**PREHEARING STATEMENT OF JOHN S. HENDRICKS AND WESTERN SKY INVESTMENTS, LLC**

**IN THE MATTER OF PROPOSED INSTREAM FLOW APPROPRIATION IN WATER DIVISION 4: LOWER DOLORES RIVER**

Re: Review of the Dolores Instream Flow Recommendation

FIGURE  
 1

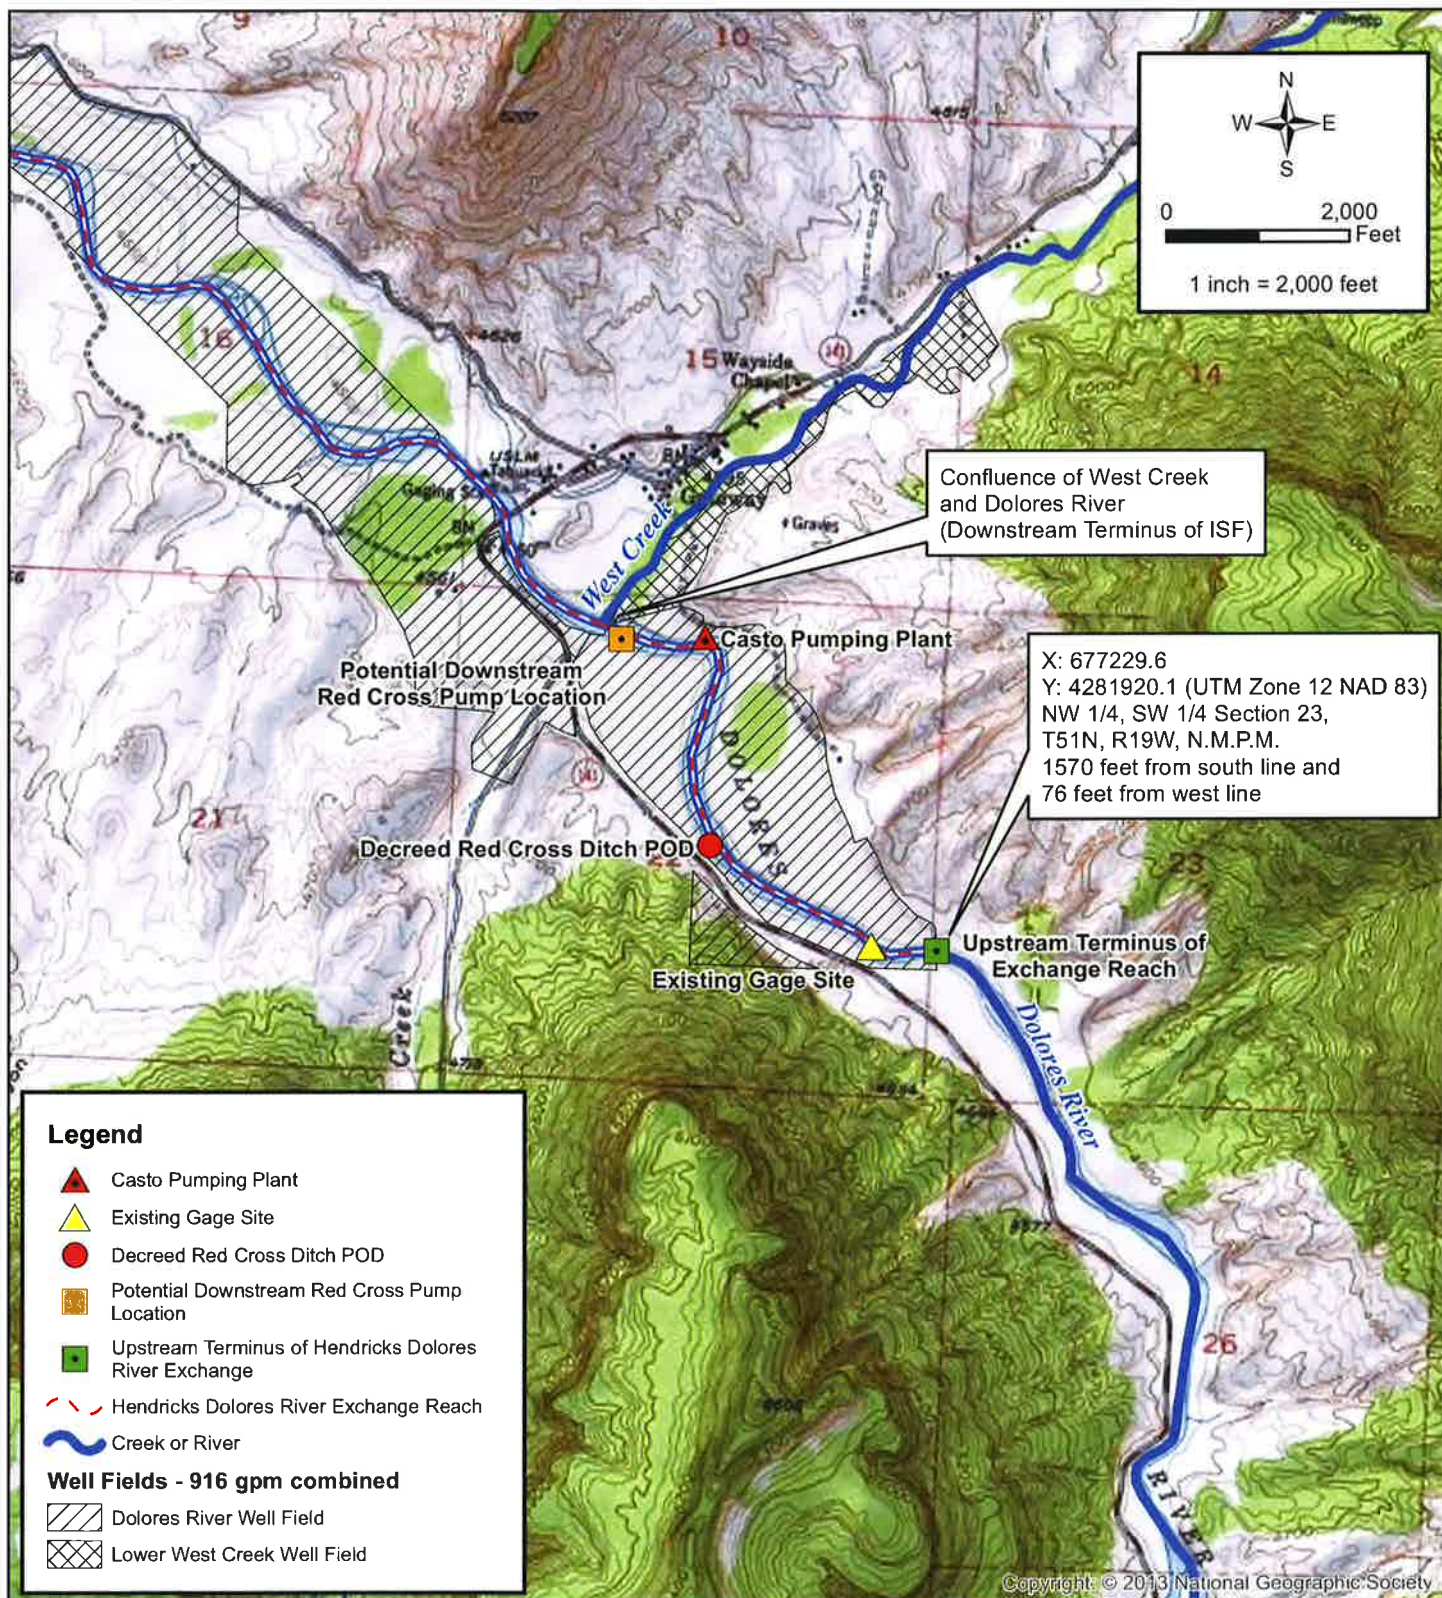
The ISF Recommendation locates the lower terminus of the ISF reach as the confluence of the Dolores River and West Creek, which is downstream of several senior water rights points of diversion including the Casto Pumping Plant and Red Cross Ditch diversion (see Figure 1).

Currently the most appropriate gage to monitor the ISF Recommendation flow levels is the USGS Gateway Gage, located on the Hendricks bridge, approximately 1.2 miles upstream of the Highway 141 bridge in Gateway, CO. WWE recommends adjusting the downstream terminus of the ISF reach to the Gateway Gage in order to reduce future water rights administration complications.

Relocating the ISF downstream terminus to the Gateway Gage will allow flows to be more accurately monitored, and thus reduce the potential for injury to senior water rights.

1. The downstream terminus of the ISF reach should be relocated to the location of the Gateway Gage as shown on Figure 1.
2. The ISF flow requirements may be revised based on hydrologic data for post development of the Dolores Project.
3. The ISF flow amounts should be revised based on drought year conditions.
